IPC Examination : Heysham M6 Link.

Presented by Michael Jacob for the Halton Residents' Group

Questions to the Examiner

Figure 10 – Illustration of daily traffic movement on Church Brow.

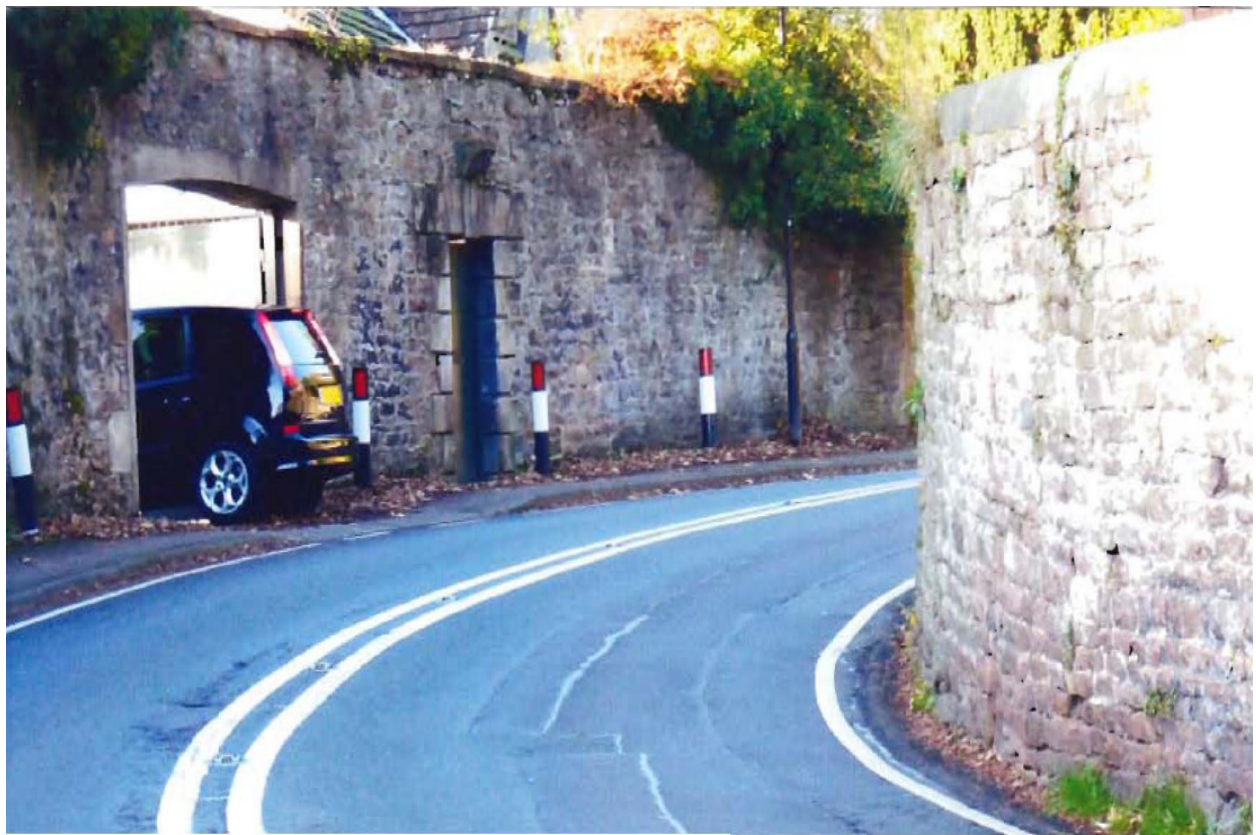
a) Has a Road Safety Audit properly addressed, in relation to Church Brow, the tight bends which unsight drivers and pedestrians, the narrowness of the carriageway which at these bends causes vehicles to cross over the double white lines (especially large vehicles), the high stone walls which edge the road and absence of pavement on one side and the narrowness of the pavement on the other (at the Tower House it is reduced to 68cm necessitating a dangerous detour with prams and mobility vehicles onto the road at the most dangerous point)?

At present the wing mirrors of many vehicles, especially larger ones, and the front ends of longer vehicles such as buses, coaches, and many commercial vehicles pass over the narrow pavement as they turn. This happens as drivers try to avoid oncoming traffic which in its turn tries to avoid collision with the graveyard wall. To avoid pedestrian fatality this issue must be addressed by the applicant.
